EPA Region 10 Enforcement and Compliance Assurance Division

Clean Water Act (CWA) Inspection Report

Inspection Entry Date/Time	01/03/2024 9:55 AM (PT)	Announced: No		
Inspection Exit Date/Time	01/03/2024 1:45 PM (PT)			
Media	Water			
Statute(s)/Program(s)	Clean Water Act, NPDES, Stormwater – Industrial			
Type of Inspection	CEI - Compliance Evaluation Inspection			
Permittee Name	Trails End Recovery			
Facility Name	Trails End Recovery			
Facility Physical Address	2060 SE Airport Lane			
City, State, Zip Code	Warrenton, Oregon 97146			
Facility GPS Coordinates	46.143889 N -123.875278 W			
Facility Owner	Custom Excavating by Dean Larson Inc. DBA: Trails End Recovery			
Facility Owner Address	2060 SE Airport Lane			
City, State, Zip Code	Warrenton, Oregon 97146			
FRS ID	110069599330			
Permit # / ODEQ File #	ORR127194 / 112084			
SIC Code	5093 – Scrap and Waste Materials (Primary), 5261 – Retail Nurseries, Lawn and Garden Supply (Secondary)			
Inspection Contacts:				
Organization	Name	Title	Present in Opening Conf.	Present in Closing Conf.

Photo #:42 (DSCN3491)

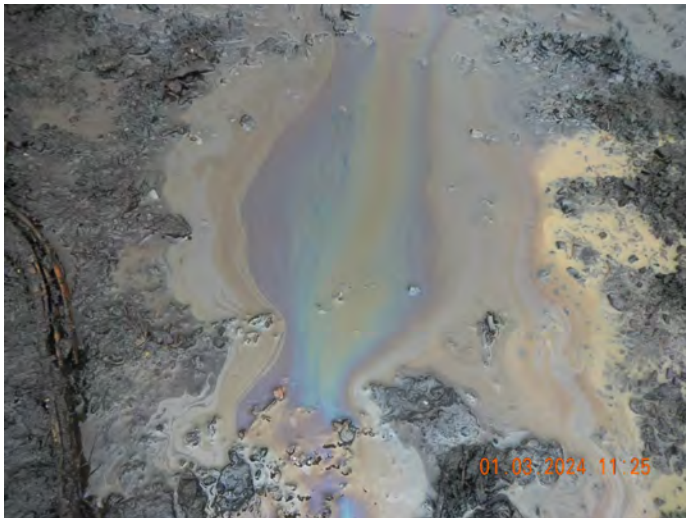
As discussed earlier in this report, during the walk-through within Sub-Basin 3, turbid stormwater from the receiving/sorting area was observed to be ponded or traveling downslope into Pond 3 as sheet flow (**Photo 44, Photo 51**). Turbid stormwater and sheens were also observed near the separating area (air separator) and was observed to flowing towards Pond 3. Stormwater entering/exiting Pond 3 was observed to be turbid.

Description: Facing northeast, photo of the air separator and processing area downslope of the air separator. Sheen/staining observed.

Description: Sheen/staining observed downslope of the air separator/processing area. Stormwater flowing towards Pond 3.

Sheen from the recent oil change on the Edge Air Screener (adjacent to inlet to Pond 3) was cleaned up with absorbent pads. Additional rock was added around Pond 3.
